**ADDENDUM NO. 1 TO PROJECT NO. 47208**

**HVAC AND ELECTRICAL WORK  
REPLACE HEATING SYSTEM OFFICE AND GARAGE  
DOT REGION 8, DUTCHESS COUNTY  
HOLLOW ROAD AND TACONIC PARKWAY  
CLINTON CORNERS, NY**

May 9, 2023

SHEET TITLE:  
 SOFFIT DETAILS

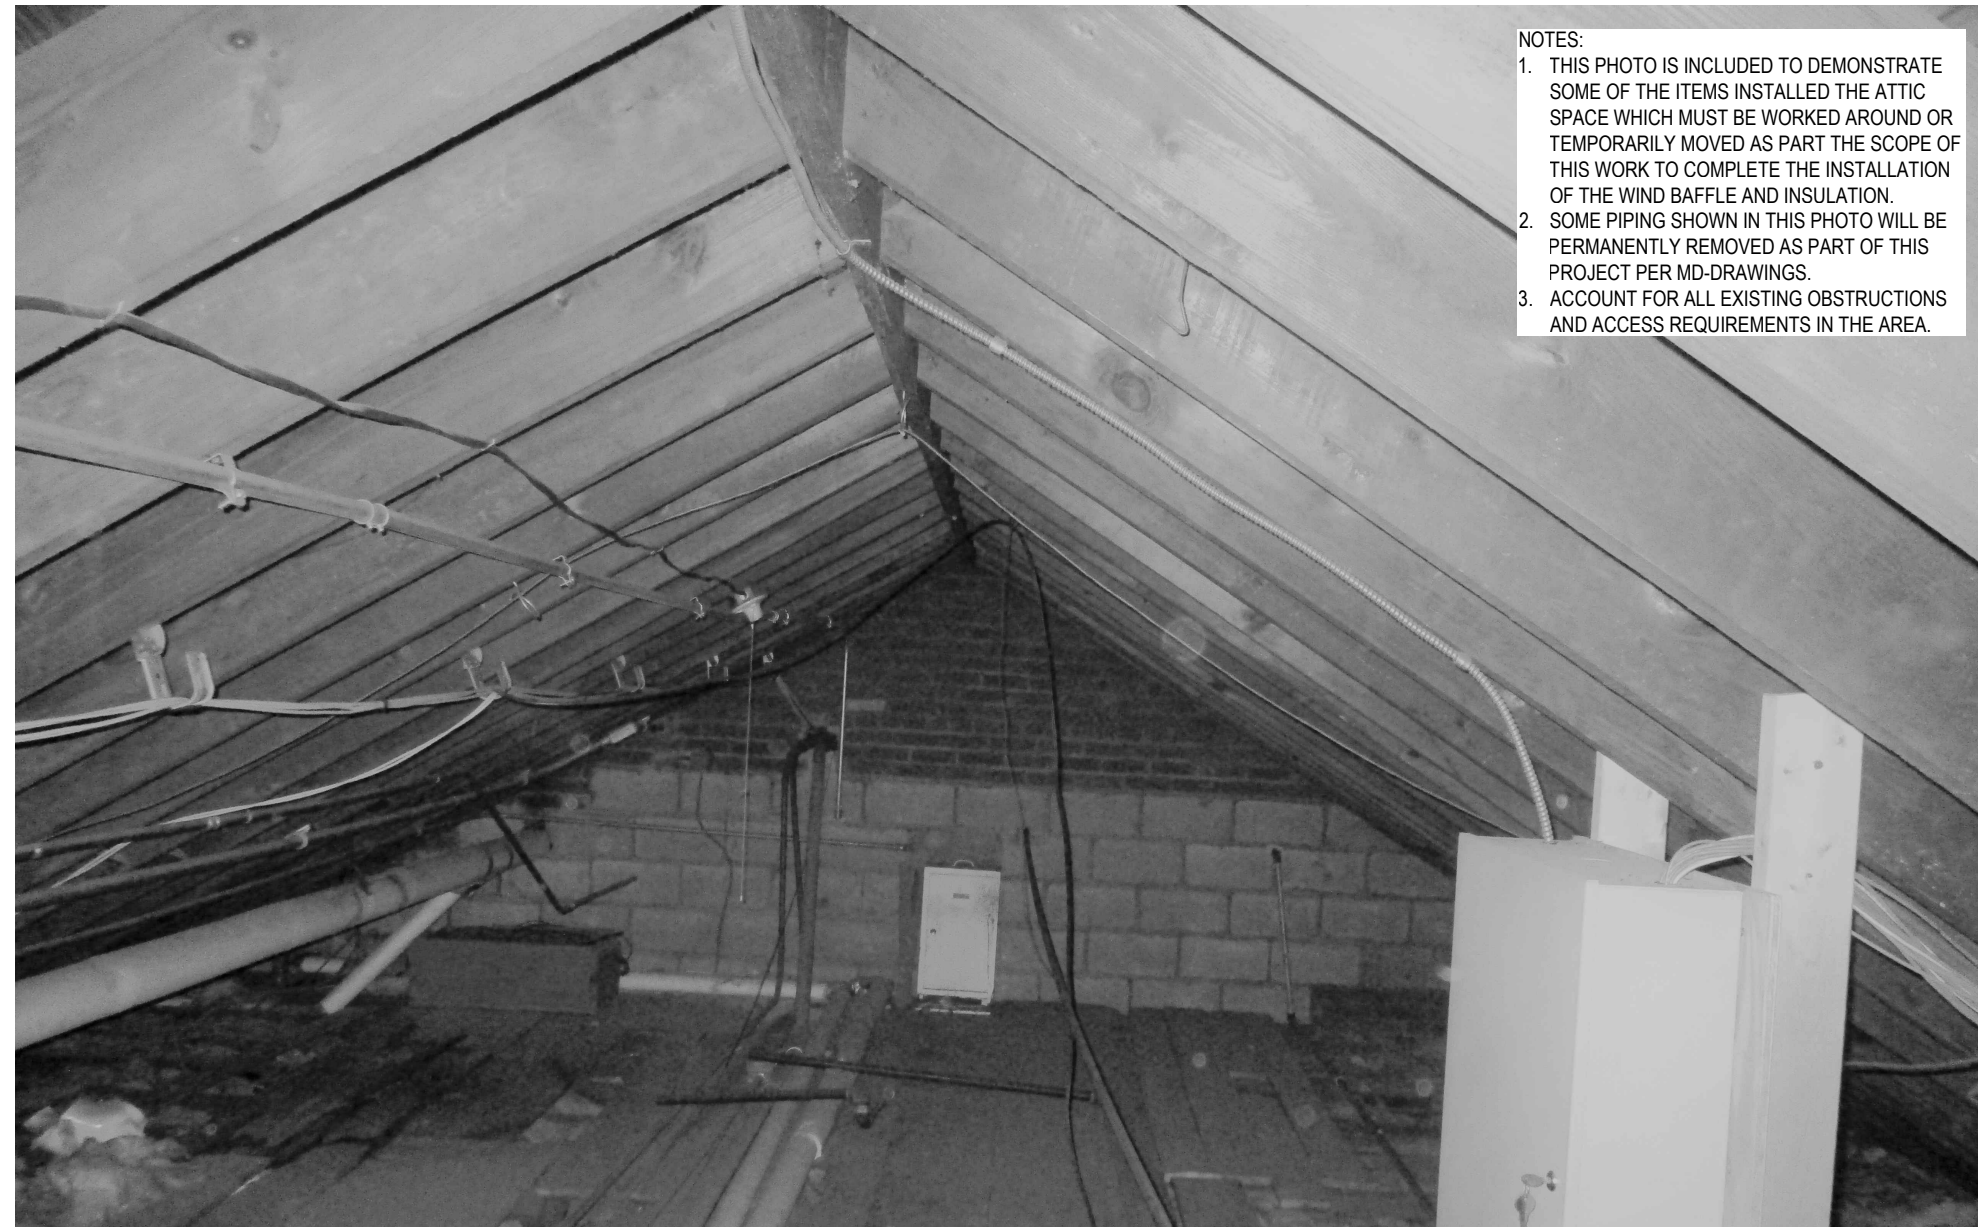
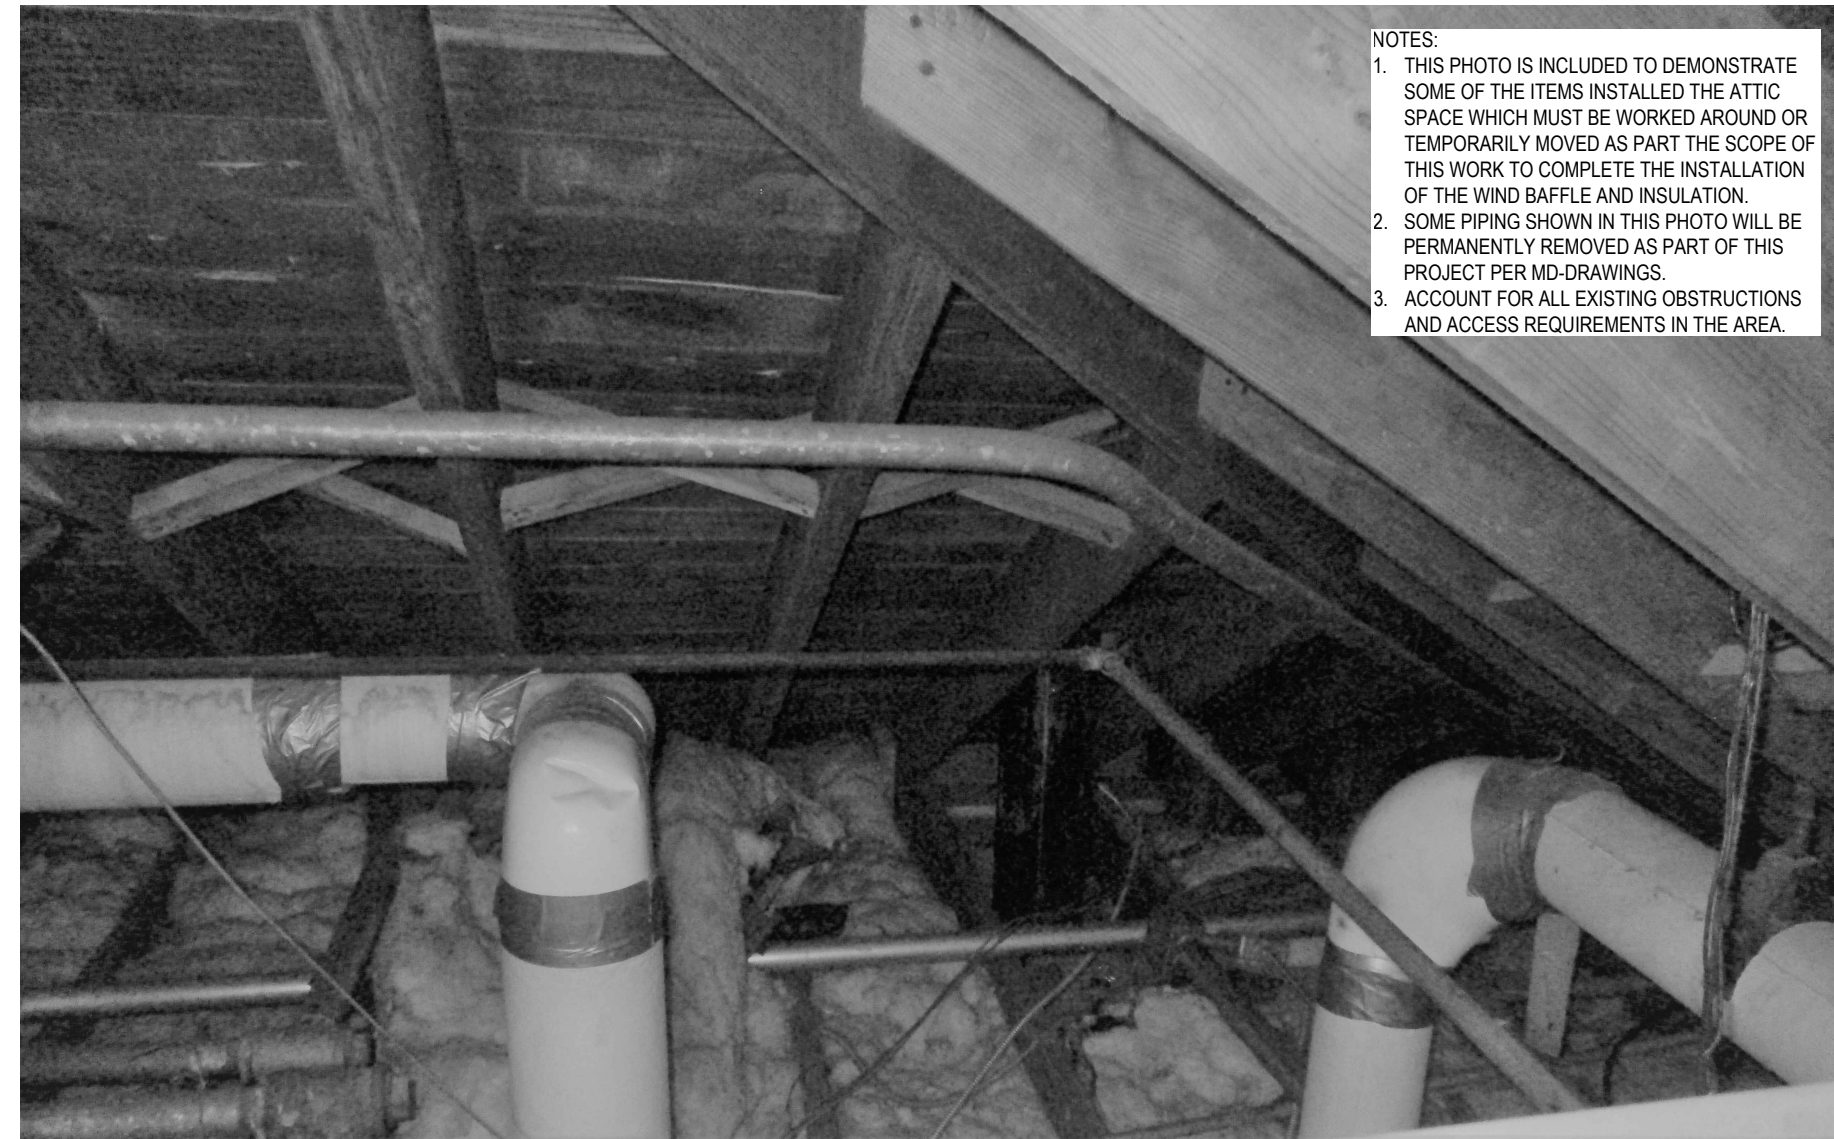
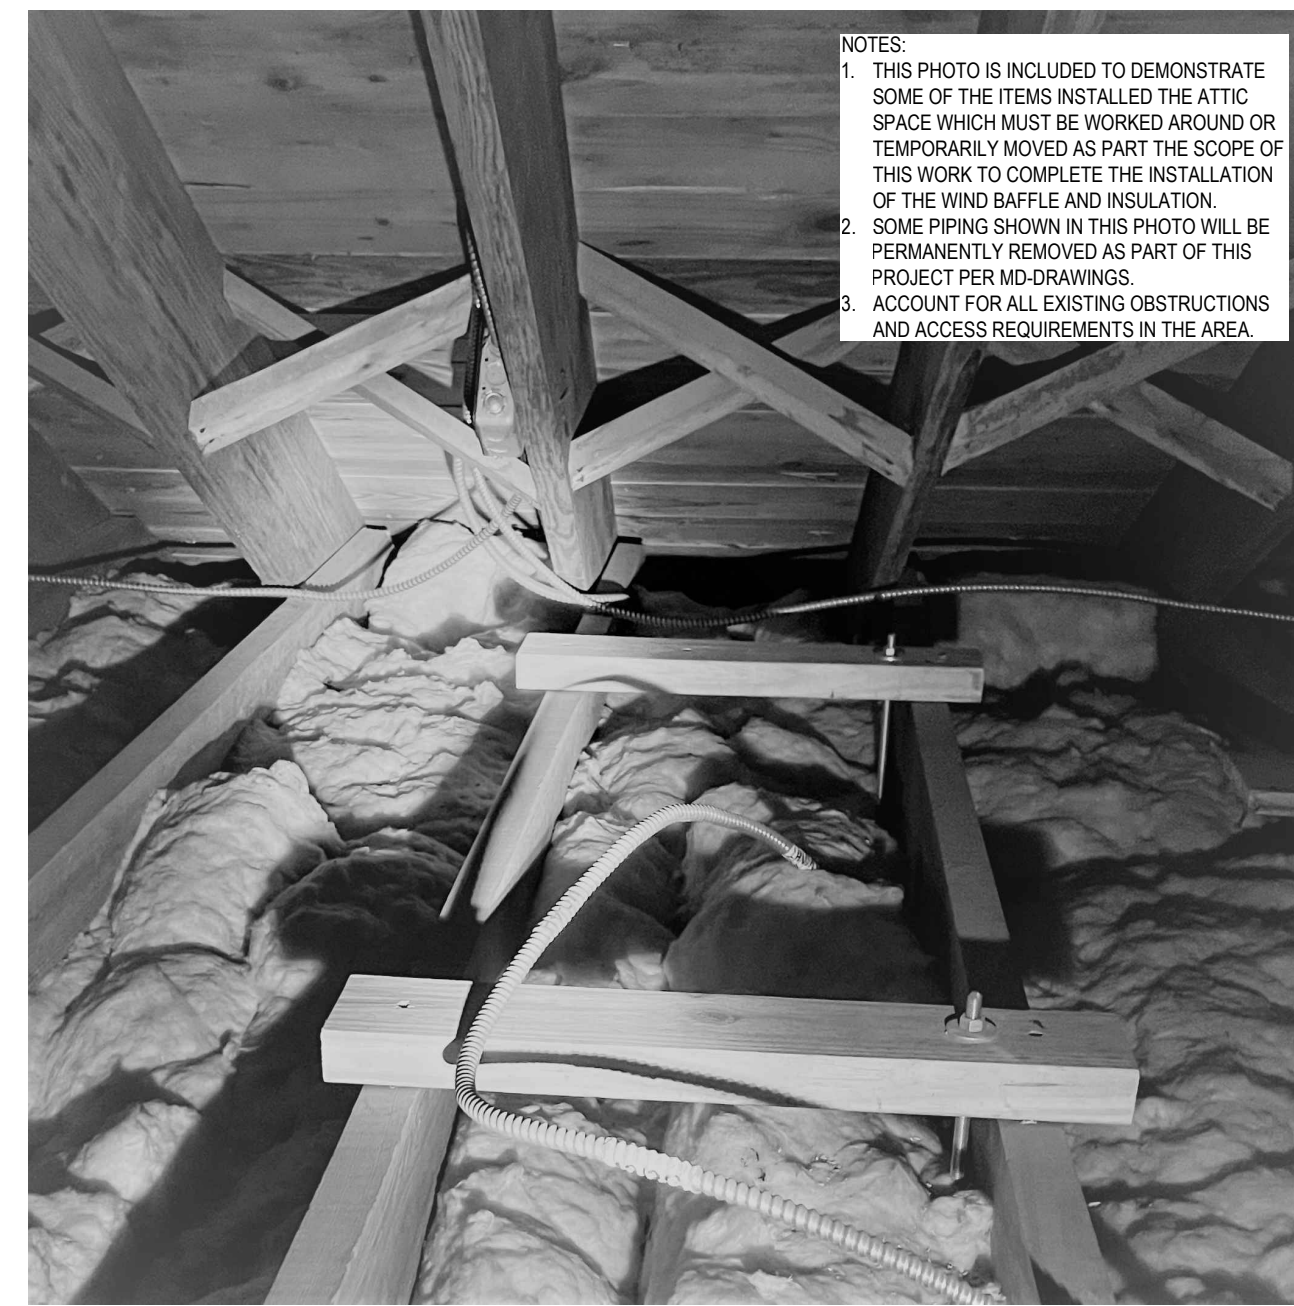
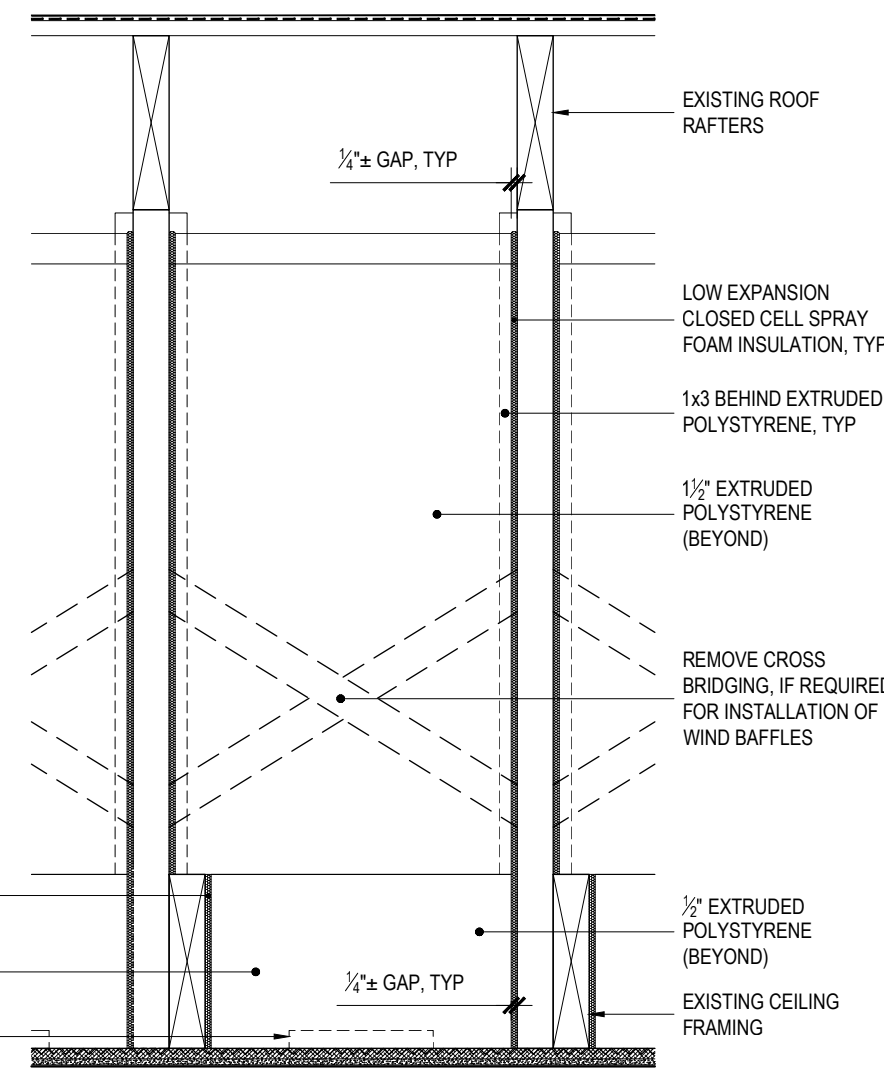
2. Revised Drawings:
  - a. Drawing Nos. G-002, A-101, A-501 and M-102, noted “REVISED DRAWING 05/08/2023”, accompany this Addendum and supersede the same numbered originally issued drawings.
3. Addendum Drawings:
  - a. Drawing No. A-503 noted “ADDENDUM DRAWING 05/08/2023”, accompanies this Addendum and forms part of the Contract Documents.
